Re: **Request for Access to Records under the Freedom of Information and Protection of Privacy Act (the "Act")**

Regarding Development Permit DP-2025-00227, record of all PTLs (Preliminary Technical Letters) from the Development, Buildings & Licensing Department and the Engineering Department, including:

From: [Casidy, Bryce](#)
To: "Maria Pawluczuk"
Cc: "Marissa Pascuzzi"; "InterCAD Services"
Subject: 2221 Marstrand Avenue - DP-2025-00227 - Outstanding Conditions Letter
Date: Thursday, November 20, 2025 12:13:00 PM
Attachments: [2221 Marstrand Avenue - DP-2025-00227 - Outstanding Conditions Letter.docx](#)
[image001.png](#)

On behalf of the Director of Planning, your application has been approved to develop a 1-storey public utility building having vehicular access from Marstrand Avenue on this existing site.

STATISTICS

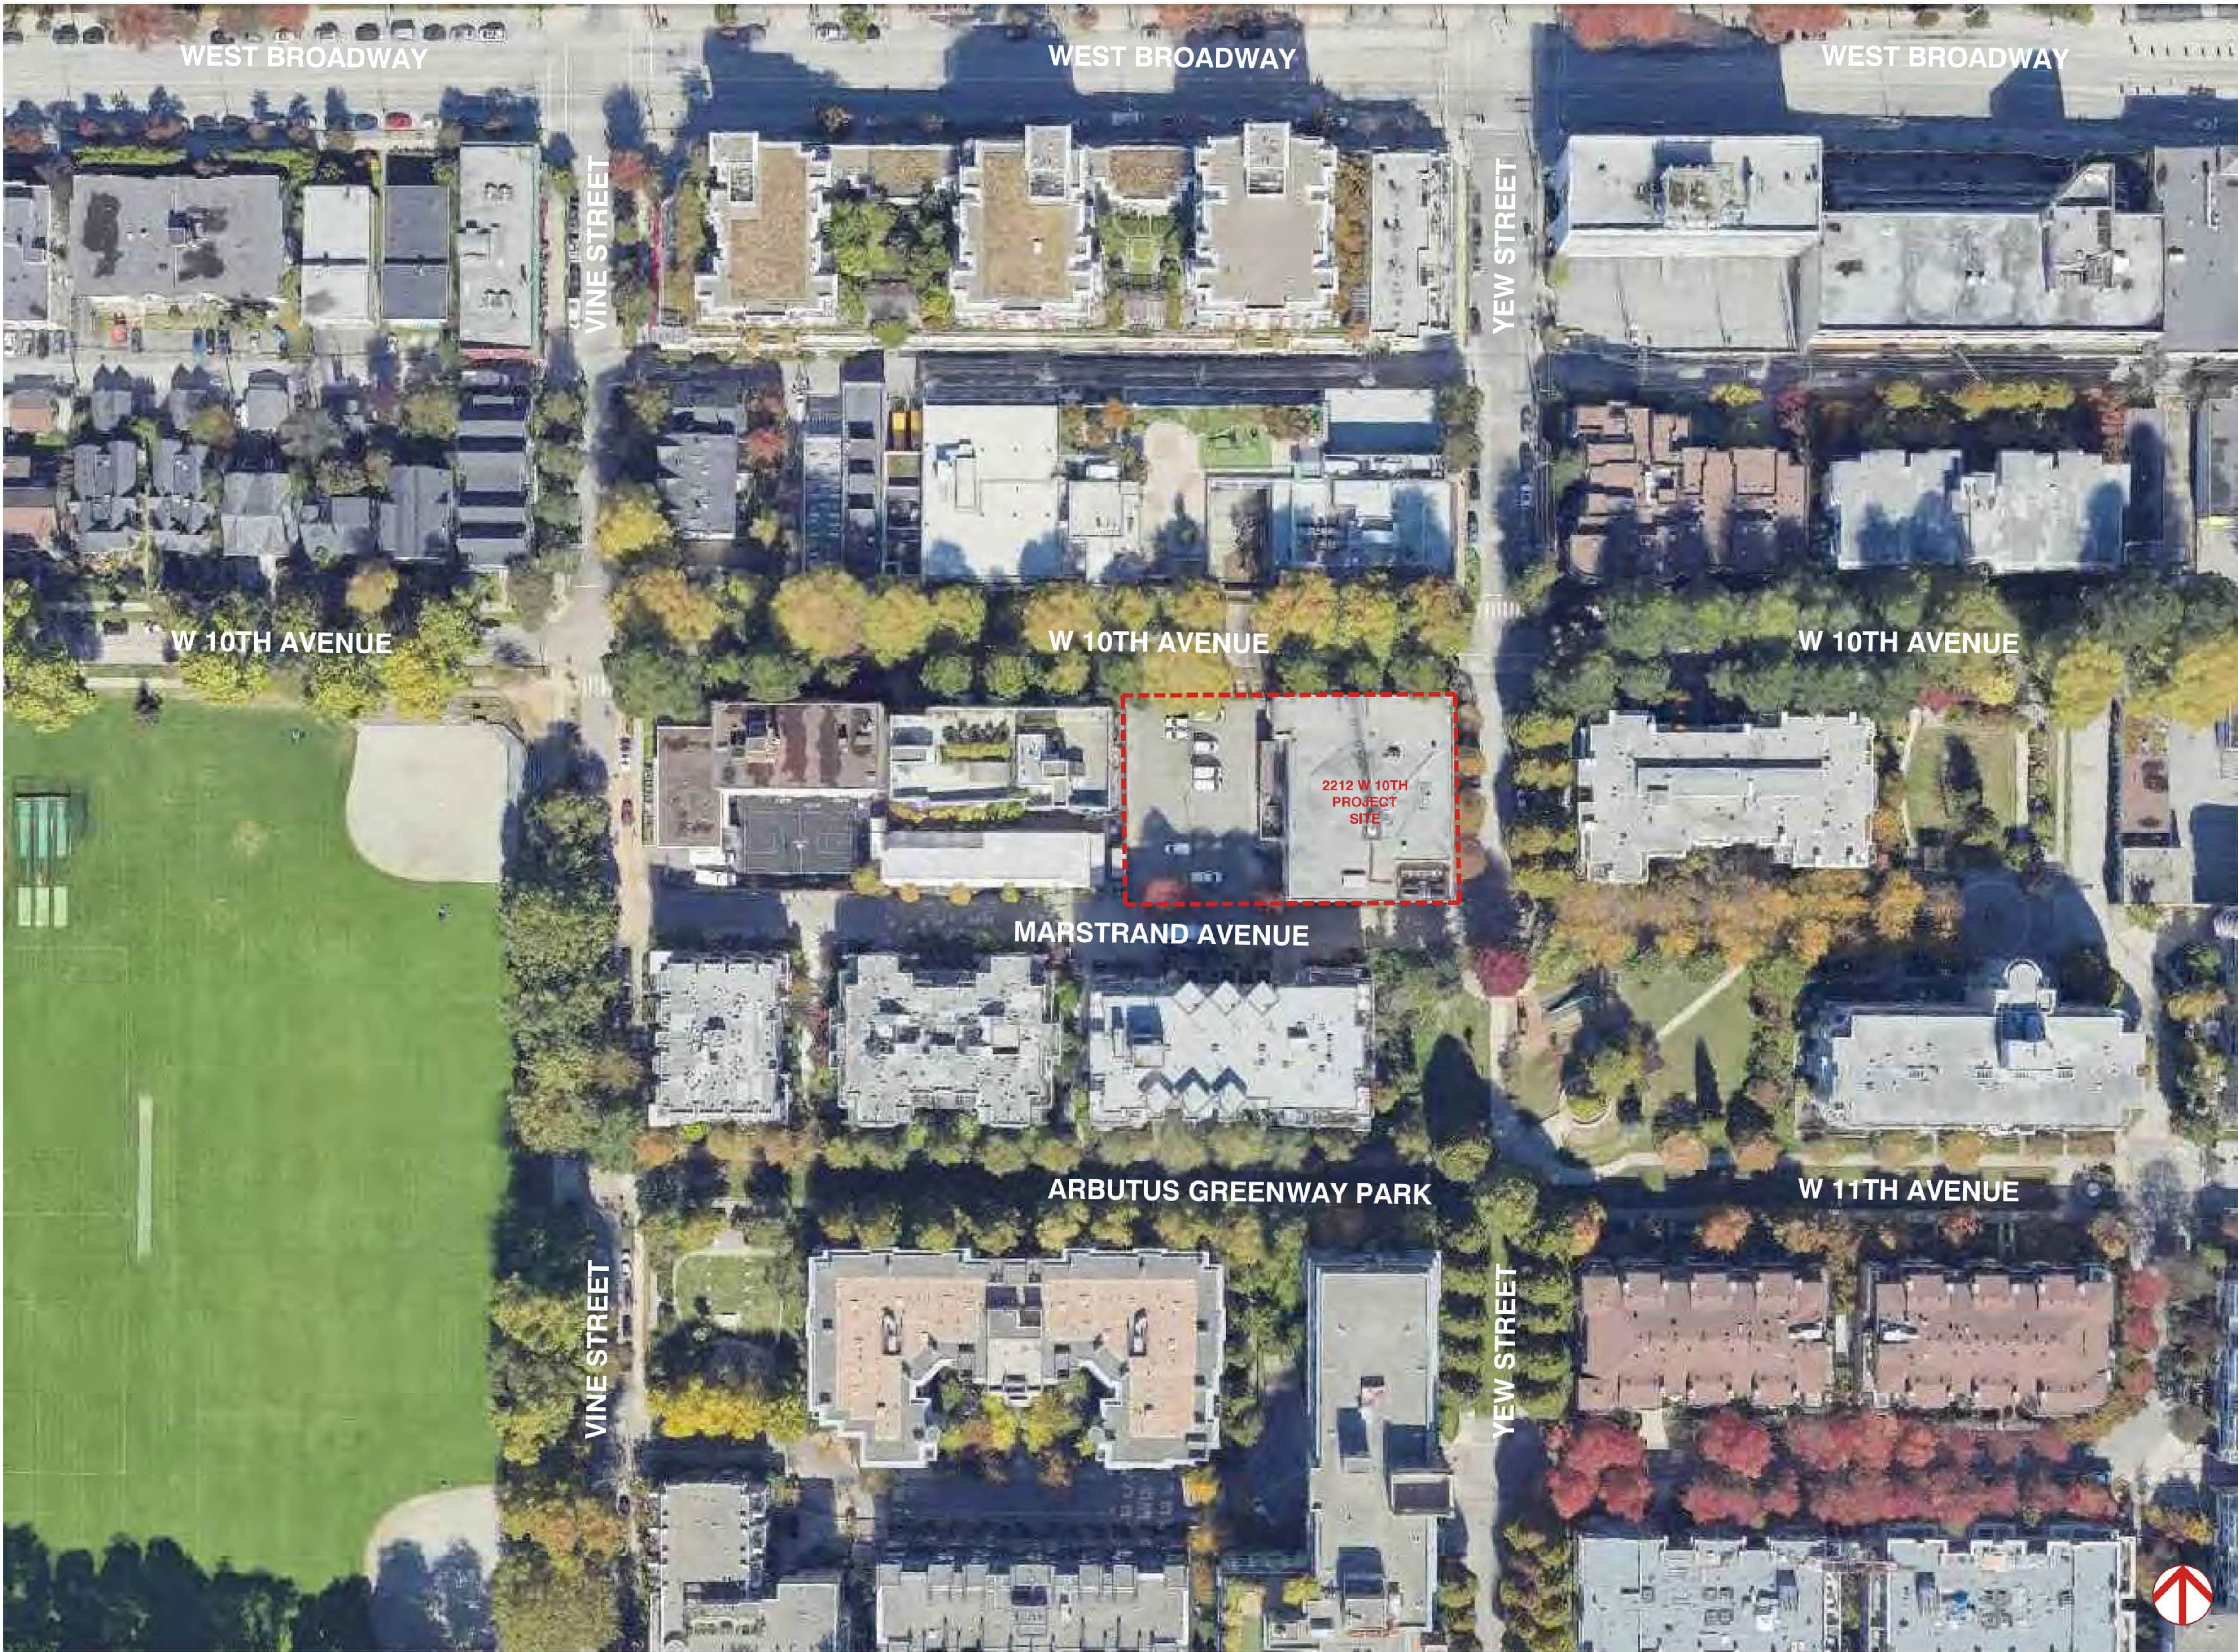
- 1.2 provision of revised FSR overlays and data summary table to include the basement level, per section 4.1.1 - Computation of Floor Area, of the C-7 District Schedule of the Zoning and Development By-law;

FSR overlays have been revised to comply with 4.1.1 Computation of Floor Area. The data summary tables have been revised to suit. Please see Page 02 and A5.01.
